East Elevations Permitted & Proposed

Project		6-7 HARDCOURT TERRACE, DUBLIN 2, IRELAND	
RESIDENTIAL APARTMENTS, LISIEUX PARK		t: 360-1-618 2100 f: 360-1-676 7385	
Murphystown Road, Leopardstown, Dublin 18		www.bkd.ie	
Drawing Title		East Elevations - Permitted and Proposed	
Stage	Scale	Drawn	Date
Planning	1:200@A1	SR	23.05.2022
Project Code	job	origin	zone
6275	LIS	BKD	ZZ
level	type	dis	sheet no.
	DR	A	2001
status	rev		
P01

2
2001
PROPOSED EAST ELEVATION (BLOCKS 1&2)
1:200

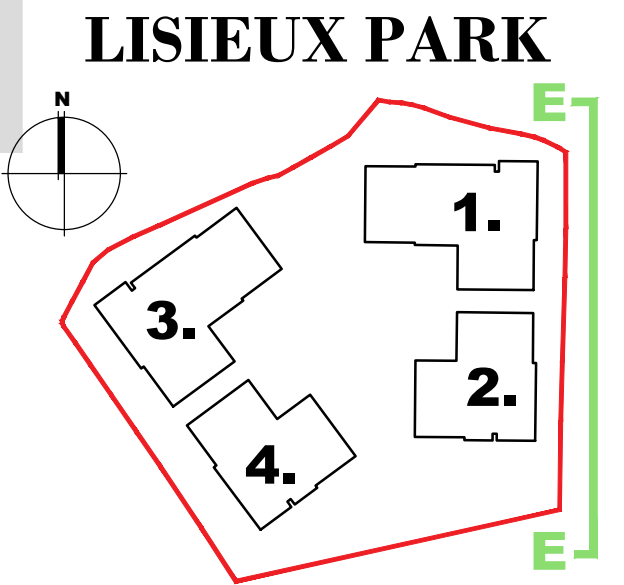
- CHANGES FROM SCHEME PERMITTED UNDER ABP-307415-20:**
- (1) ALL PERMITTED BEDROOM DOORS OPENING ON TO BALCONIES CHANGED TO WINDOWS TO IMPROVE SAFETY AND SECURITY.
 - (2) PERMITTED GLAZED ATRIUM AT ROOF LEVEL (ABOVE STAIR AND LIFT CORE) REMOVED FOR FSC PURPOSES
 - (3) GLAZED LINK CORRIDORS BETWEEN BUILDINGS REMOVED
 - (4) FENESTRATION SHOWN IN ELEVATION TO TALLY WITH PERMITTED PLANS
 - (5) MINOR CHANGES TO FENESTRATION TO ACCOMMODATE IMPROVED APARTMENT FLOOR PLANS
 - (6) NON-STRUCTURAL COLUMNS OMITTED FROM BALCONIES TO IMPROVE DAYLIGHT INTO APARTMENTS
- NOTE: TREES SHOWN AS INDICATIVE ONLY. REFER TO THE ARBORISTS REPORTS, TREE PROTECTION PLANS AND LANDSCAPE MASTERPLAN FOR DETAILS ON ALL TREES
